Planning Commission
CITY HALL COUNCIL CHAMBERS
AGENDA OF JANUARY 14, 2025
7:00 PM

PPZ2024-0319: Development Plan

CITY LIMITS
RESTAURANT & LOUNGE
PATIO & PARKING LOT IMPROVEMENTS
SITUATED IN THE CITY OF NORTH RIDGEVILLE,
COUNTY OF LORAIN, STATE OF OHIO

SHEET: **C2.0**

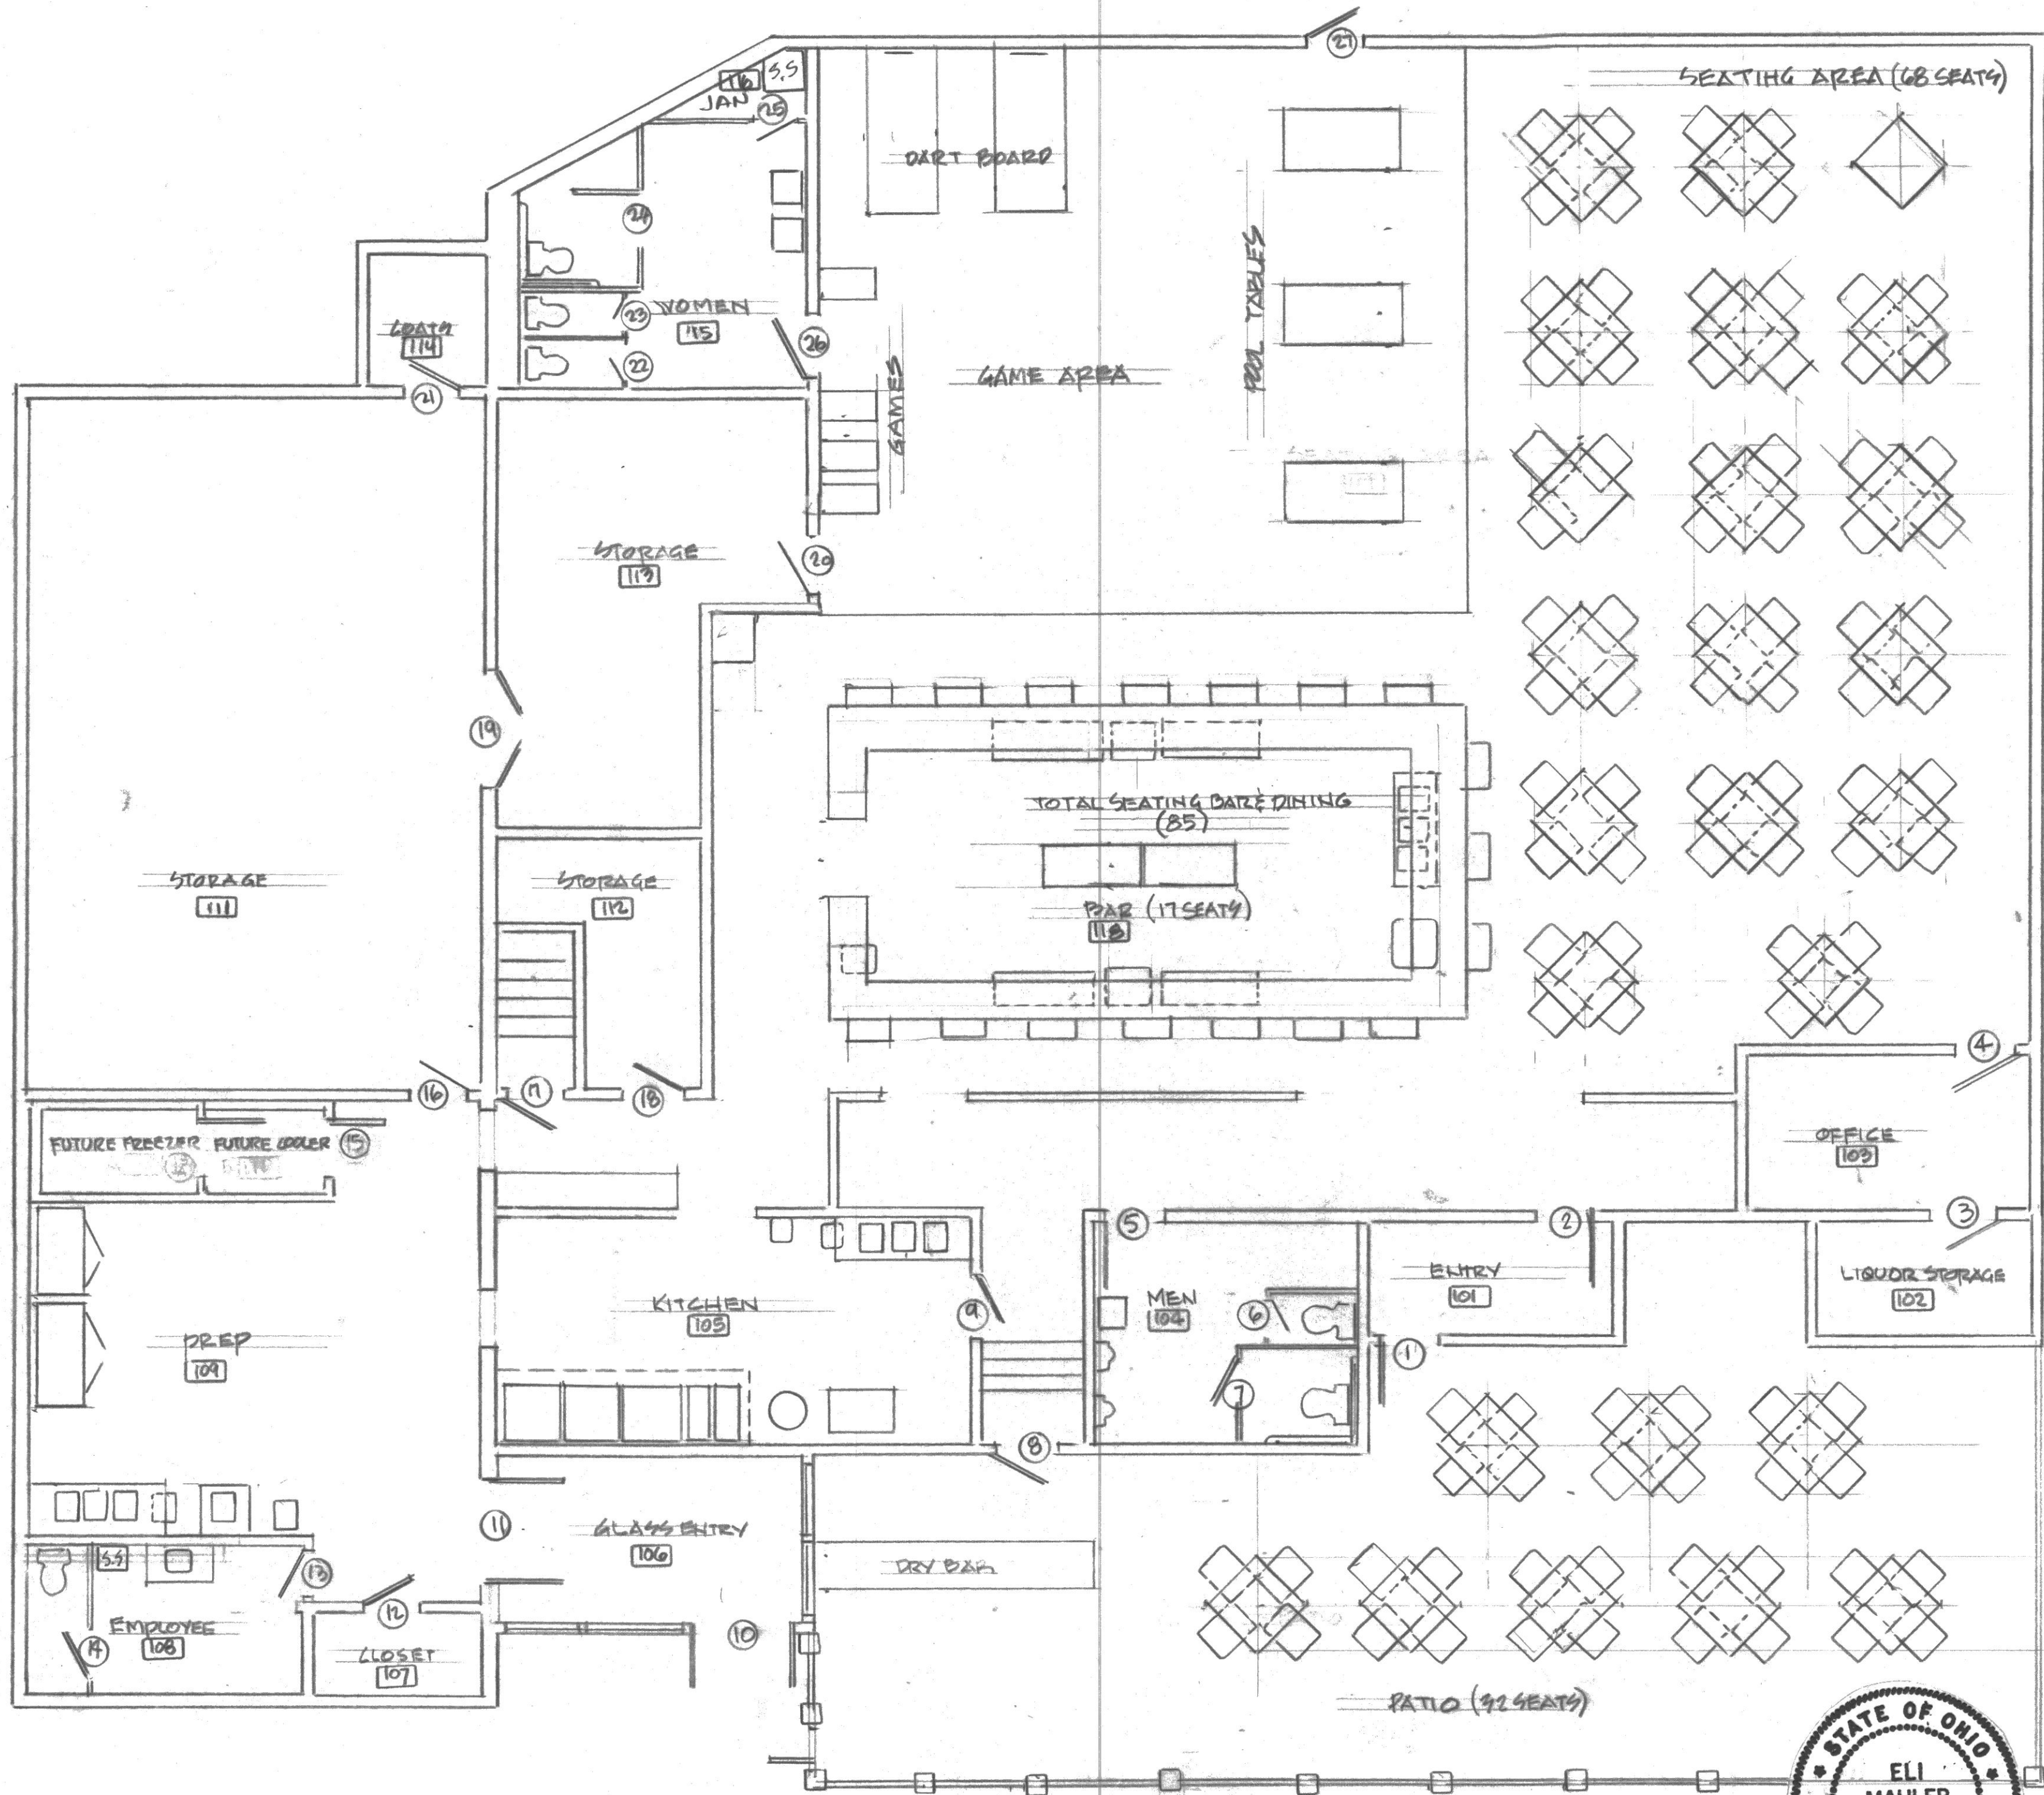
In the current condition, ingress and egress is not well defined. Parking will be reconfigured to provide the required setback from the ROW. The proposed plan shows use of paint striping to delineate one way in and one way out. Parking spaces are properly sized and the plan includes ADA spaces. Based on the proposed seating, parking is adequate. A total of 50 spaces are provided, which satisfies the 39 required for the lounge/restaurant plus salon. It is recommended the parking lot be patched, sealed and restriped.

Some landscaping has been provided. The applicant proposes landscape planters adjacent to the building and west of the ingress drive. Raised beds are shown around the ground sign and along the ADA ramp. More detail and definition of the site landscaping is needed.

- Provide more detail on the elevations to include proposed colors, materials and construction detail.
- Improve landscaping detail.
- Ensure railing is provided around entire patio portions above grade.
- Photometric plan and light fixtures are needed for review.

- Kim stated that in the last meeting they had discussed the parking lot and the need to create better definition of the drive aprons and remove some of the striping that went into the right-of-way, and it appeared that that was done. She mentioned that the parking lot widths and spaces were all properly sized.

- Kim discussed that regarding parking, it was noted that it would be resealed and restriped but asked if he could add patching prior to resealing to even out spots and note it as repair, reseal and restripe. Kim stated that regarding parking it looked like they needed 39 and they were showing 50, so that would be plenty, even with the salon.

- Kim asked if the landscaped areas along the frontage were going to be cut in. Stephen stated there would be a raised bed around the main sign and a flower bed adjacent to the patio. For the rest of it he wanted concrete pots with potted plants in the front of the building. Kim asked if there would be curbing or he would be defining the ins and outs with pots. She asked for the specs on the pots and Stephen stated that they would be 30 inches in diameter and 20 inches tall and would have an evergreen in each of them. He mentioned that he would plant Winter Gems in front of the building. Christina asked if they would be structural concrete pots that would be out all year or were they something that would be out only in the summer. Stephen stated that it would be year-round. Christina discussed that the pots were a concern if someone were to leave the right-of-way as they would be non-breakaway.

- Stephen mentioned that he would mark the ins and outs with signs. Kim stated that they would need a detail on those signs because of where they would be located being really close to the entrance drive and explained that there were requirements regarding the max height and area location.

- Kim asked if the front left area would be striped with the containers on top and Stephen stated that was correct. Kim asked about the east of the exit drive, all of that area, but not where the flower bed would be, would be striped off and then that would be landscaping along the building part with a flower bed along the ramp. Stephen stated that was correct. Kim asked about the back of the lot regarding landscaping, the area that would be cut out and asked if that was topsoil or if it would be plants as well. Stephen stated that it was stone and at the edge of the driveway he would plant Winter Gems there so that no one could get back in that triangular corner. Kim asked how he would prevent it from having weeds growing up through the gravel. Stephen stated that he was going to dig it out about three feet wide and put a weed barrier down and then plant the Winter Gems and mulch. Kim asked about the area in the point of the triangle behind that being maintained. Stephen stated that most of that area back there was telephone poles, but he would maintain it. Kim asked about the

- Kim recapped that where those parking spaces were labeled 35 to 40, that area to the west would be grass and then the landscaped area with the winter gem shown just to the north of spaces 41 to 44, that would be topsoil and would be planted and mulched with those evergreens and then, further north beyond in that point that would be graveled and maintained as gravel. She asked if they could add clarification around what the intent was for each of those areas, so noting that the area would be changed into grass and maintained gravel and adding soil and plants.

- Kim stated that he showed proposed lighting on the site plan but didn't provide a photometric plan or any lighting cut sheets and those would be needed to determine if the lighting levels met the code requirements.

- Christina asked about the raised patio and commented that it looked like it was going to be pretty steep up the back end and asked if he intended to put in a fence or a rail. Stephen stated that there was a rail but that it didn't show up in the drawing. Christina stated that he had the elevation for the patio floor but didn't show what the elevation was of the parking lot. Stephen stated that he wasn't sure but thought it was 60 inches from the parking lot up and that he only did 7-inch risers on the drawing. Christina stated that it needed to be clear as to all sides

- The applicant will provide updated plans by Friday, January 10 for the January 14 meeting.

FLOOR PLAN

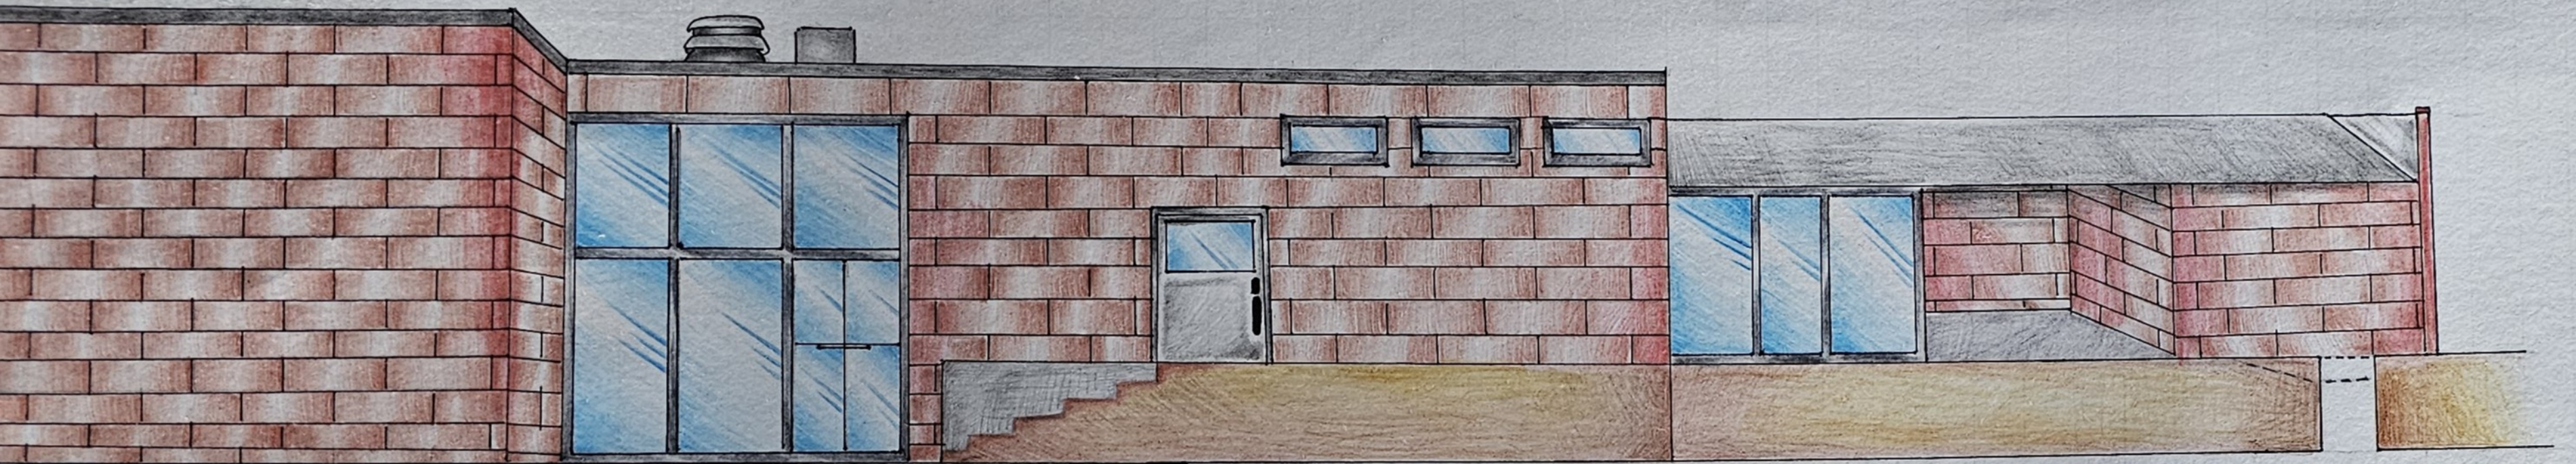
- Kim asked regarding the elevations, there wasn't any notations or detail about what was happening and asked if he was showing the intent to maintain existing brick as is. Stephen stated that was correct. She stated that she didn't understand what was happening with the south façade and asked if he was proposing some kind of plaster or stucco. She stated that typically an architectural elevation would label materials and colors and have a little bit of construction detail. She explained that she wasn't sure if those were new canopies over the windows or were existing and suggested less art and more detail.

- Kim stated that there were boarded up windows on the south elevation and asked if they were going to be removed. Stephen stated that those were glass block and were getting lantern lights there. Chief Reese recommended the addition of windows for safety. Geoffrey asked if they wanted elevations and Kim stated that they did as well as floor plans, walkways and landscape plans.

SHEET: C1.0

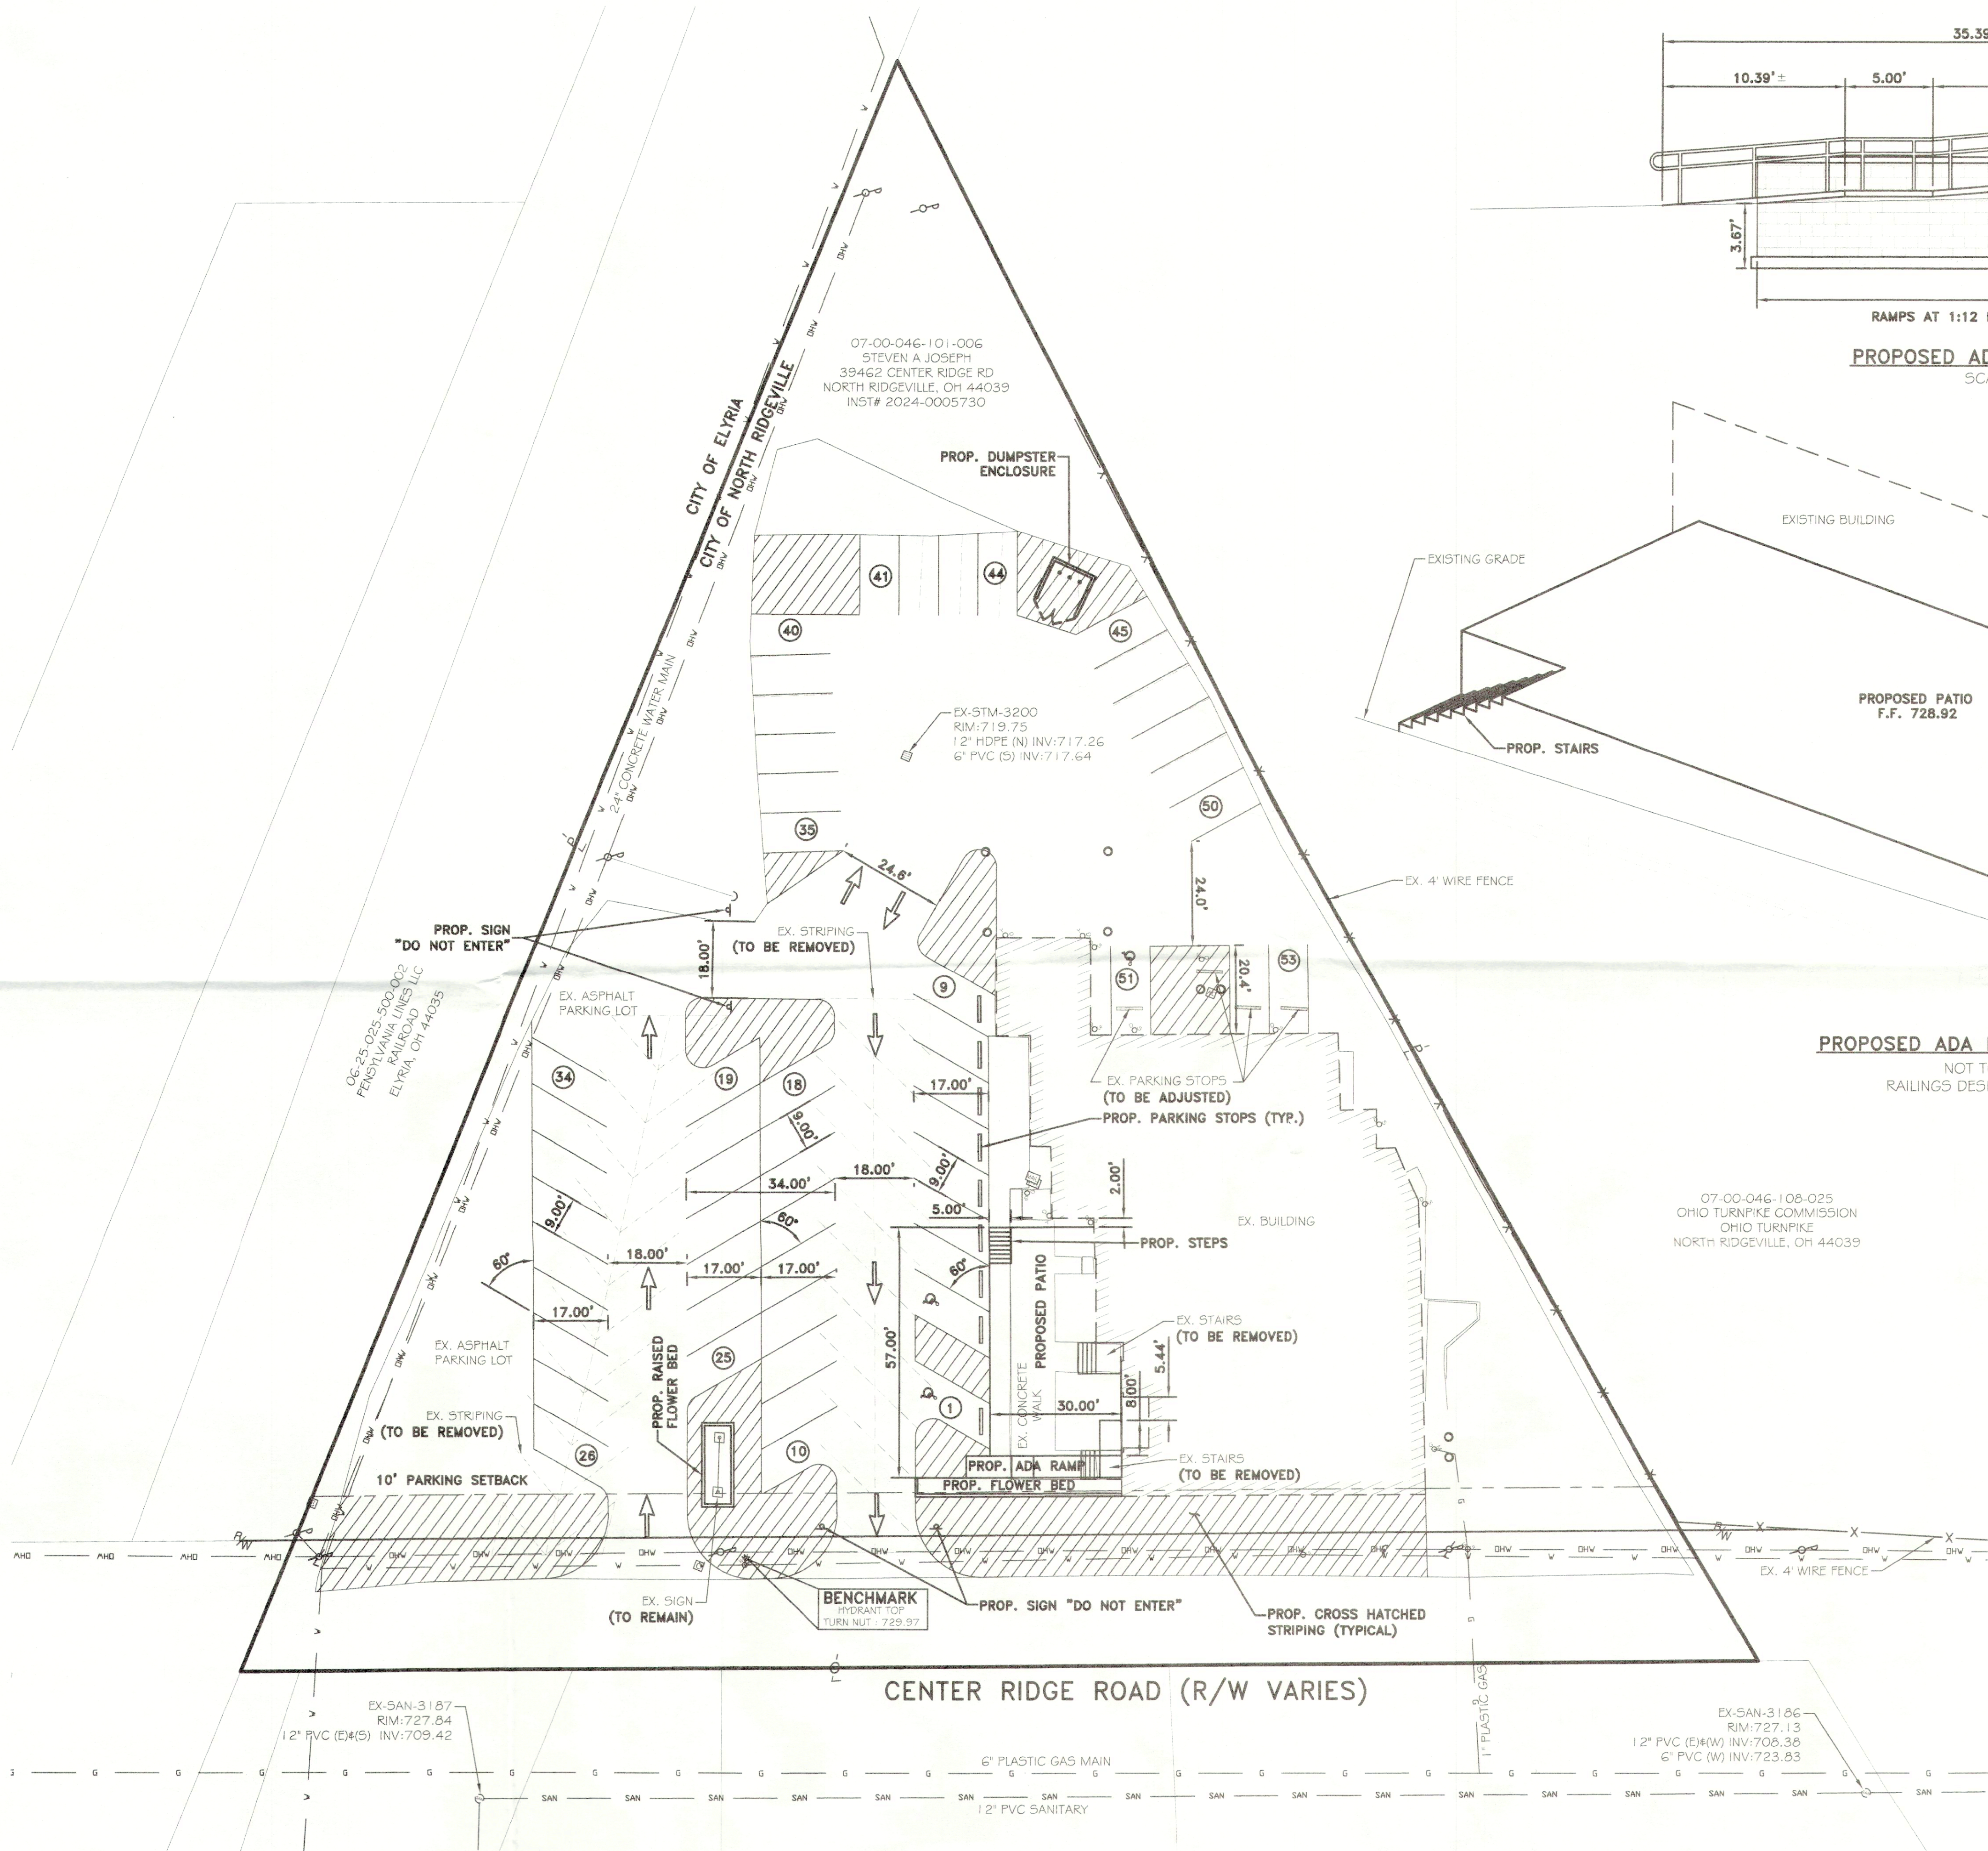
In the current condition, ingress and egress is not well defined. Parking will be reconfigured to provide the required setback from the ROW. The proposed plan shows use of paint striping to delineate one way in and one way out. Parking spaces are properly sized and the plan includes ADA spaces.

- Square footage and seating capacity of restaurant/lounge is needed to determine required parking count.
- It's unclear whether the patio is sized to accommodate tables and chairs.
- Will boarded up windows on south elevation remain?
- Provide landscape plan. Expand landscaping adjacent to building and around sign. Landscape around sign could be used to better define ingress/egress aisles. Improve area between building and ROW which is currently cracked pavement and weeds. Improve weedy area west of building toward rear of property.
- Recommend resealing and striping of parking lot, not just restriping.
- Provide detail of dumpster enclosure.
- Any new lighting proposed? If so, photometric plan and light fixtures are needed for review.

- Kim stated that the existing building was nonconforming. She noted parking as currently shown encroached in the right of way. To determine required parking, she stated that they needed to show the square footage of the inside of the building and seating capacity. She discussed that adding a patio would also add an additional area for patrons which would need to be factored in if there were going to be seating. She asked if his intent was to put tables and chairs on the patio and Stephen stated that it was. She stated that it would be helpful to see how that would fit. Stephen stated that he wanted a seating capacity of 60.

- She asked if he was going to be resealing the parking lot and Stephen stated that he was. She asked that he show that on the plans. She stated that they would need a detail of the dumpster enclosure and asked if there was going to be parking lot lighting. Stephen stated that he was going to change them out so that they were brighter. Kim stated that if they were changing out the lights that they would need a photometric plan provided by their engineer to show that it met the requirements for illumination and would need a cut sheet of the light fixtures as well.

- The applicant will provide updated plans for the January 14, 2025 meeting.
